URBAN DESIGN COMMITTEE

AGENDA

UDR25011 Bison Witches Sidewalk Cafe

Revised design of the Southwest corner (submitted for the June 03 meeting)

1 Wall Section
1" = 1'-0"
0 1 2

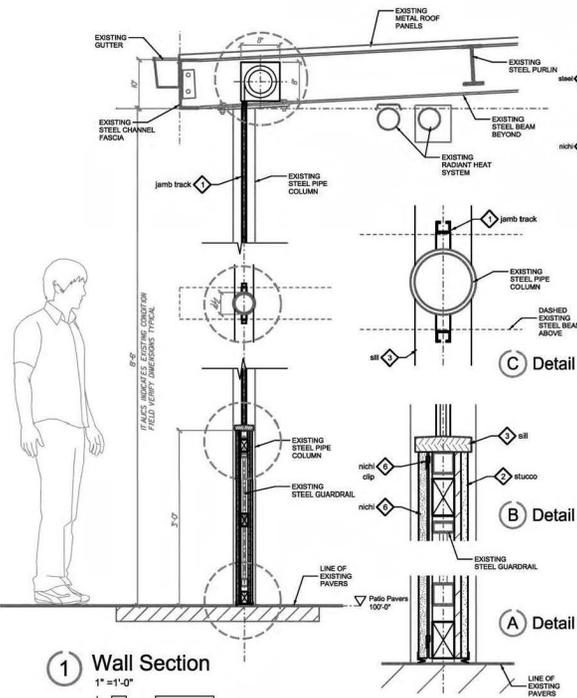
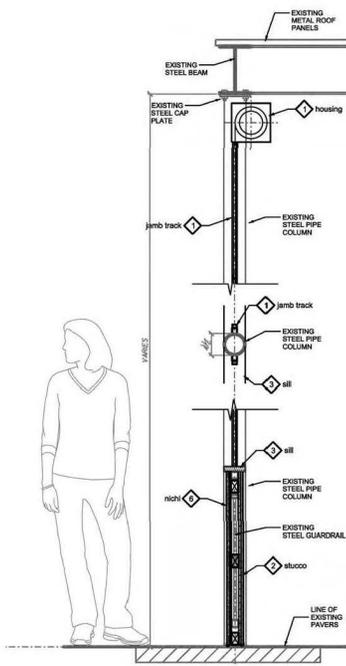
The first concern is aesthetics. The enclosure does not align with the surrounding design and contrasts with the public space's intended openness.

Second is lack of transparency. The current enclosure obstructs sightlines, diminishing pedestrian engagement and disrupting the synergy between public and private spaces.

Third is approval from the artist. Modifications to the blue tile wall or pavers require approval from the artist under a 30-year agreement. Staff have reached out multiple times but have yet to receive a response. If the proposed design does not require removing pavers, it may proceed. However, any modifications requiring footings must be approved by the artist.

Compatibility per Staff Analysis: *The revised proposal introduces key design improvements, including opaque segmented walls with a masonry panel system (color TBD), transparent storefront doors and windows, and a motorized shade*

Along the existing handrails, he proposes a segmented wall that follows the curvature of the tower. This system functions better if the enclosure height is limited to about six or seven feet. The floating yellow wall will provide a sealing surface for the curtains. The color is currently proposed as yellow to align with the surrounding aesthetics, but it could be a neutral gray if necessary. The plan also proposes installing an aluminum and glass storefront system on the north and south sides, ensuring greater transparency. This approach minimizes invasiveness and avoids deep foundations or structural changes.

Peace stated the existing handrail is a stout steel structure with vertical bars. We plan to attach a floating steel-clad or stucco wall to this handrail without tearing out the pavers or installing deep footings. If the artist has input, he will certainly take it into account.

10th St entrance (presented at the May 06 meeting)

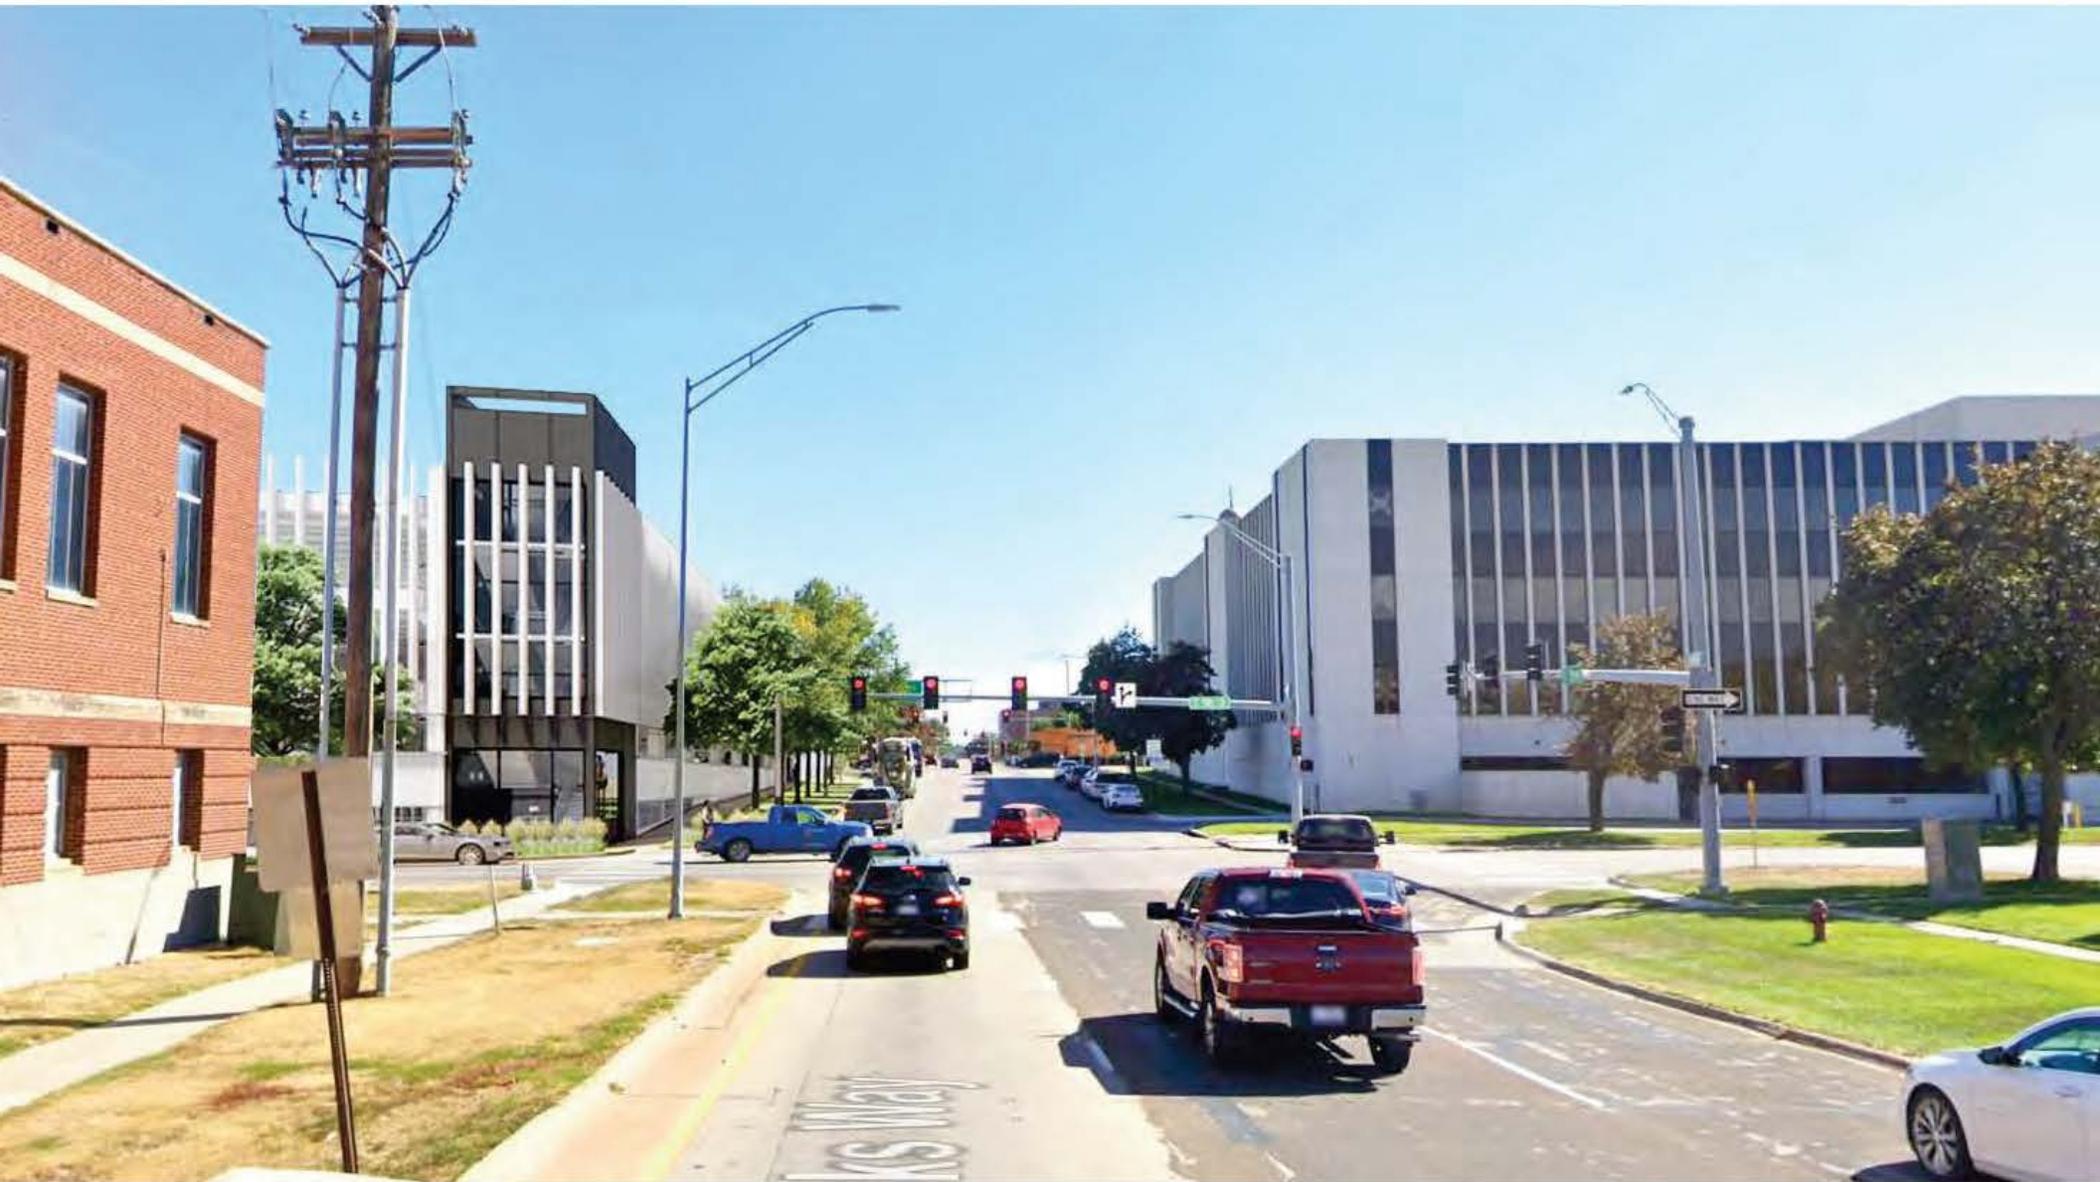
Grasso said, when driving down Rosa Parks, it is flat, and it is clear with the wayfinding on 10th Street where the entrance and exits are located. There needs to be something more than just wrapping the fins and something brought down at the streetscape level. The visual should not be high, but more at the street level. This would make it more of a campus and not just someplace to park. Grasso wanted an explanation on the night view.

To enhance the identity and visual appeal of these façades, staff recommends omitting fins on the stair tower and incorporating windows on the south side. We recommend that the façade remain relatively simple, with a darker finish to create a strong, clean contrast, like the stair tower on the Southeast Corner. While the current project does not include public art or mural work, this understated design would provide an ideal canvas for a striking and impactful artwork in the future.

In response to these comments, the design team has submitted an updated design for the southwest corner of the garage.

SITE LAYOUT PLAN
SCALE: 1" = 20'-0"

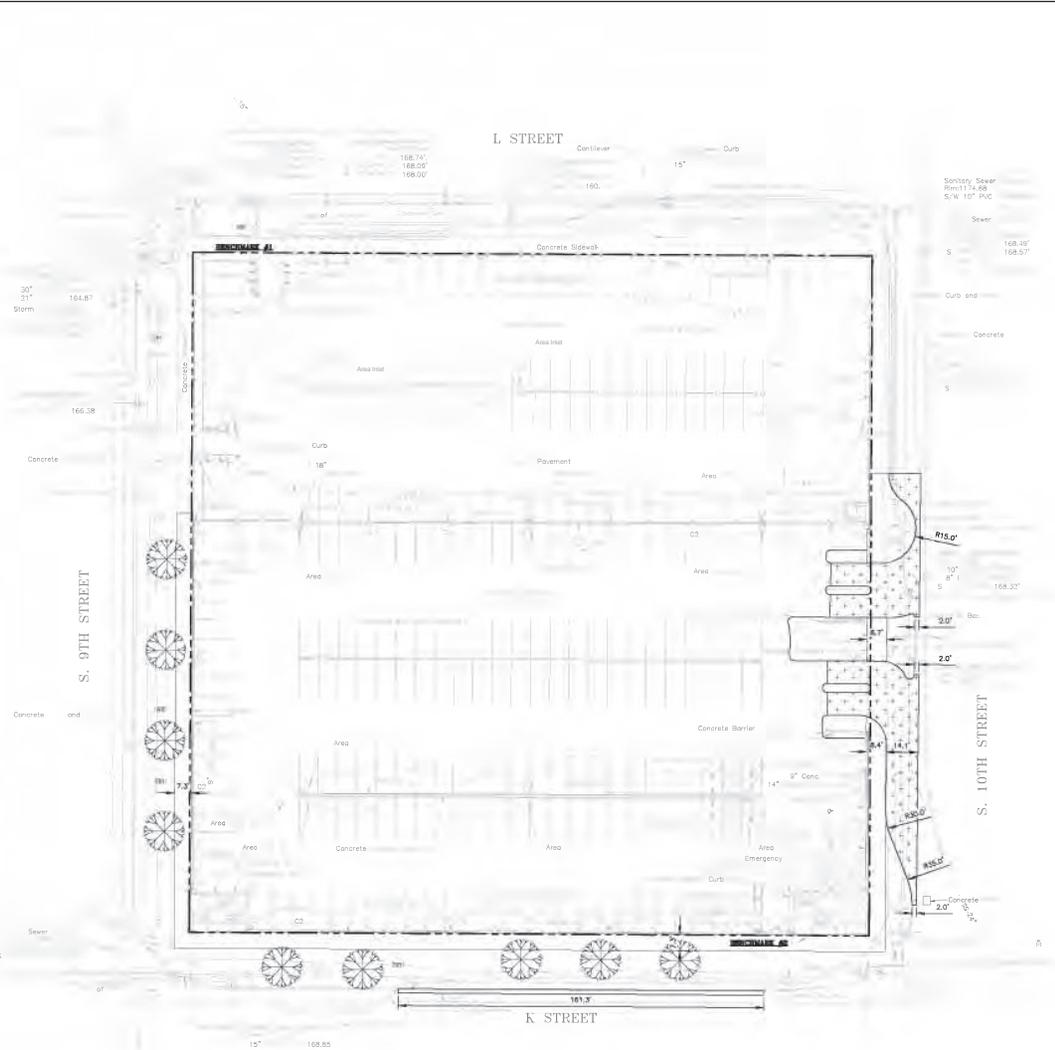
Penn asked if the site plan has been updated now with the downtown corridor and that it seems to show more trees on the corridor master plan.

Deeker said there is a double lane on 10th street, which the downtown corridors did not anticipate and does that account for not having four trees planted at this spot.

Burnett mentioned the topic of trees. There are a lot of utilities on this block to try and avoid. Electrical lines, fiber, storm sewer and water. These things that are located on the Southeast part of the block make it crowded, and then there is a turn lane into the garage on the North half. The trees have about 40-foot spacing, so it could potentially be shifted down to get another tree planted. We will work with Collin Christopher to see if the requirements are being met for the 10th Street streetscape.

Gopalakrishnan said Yes, the plan shows the downtown corridors.
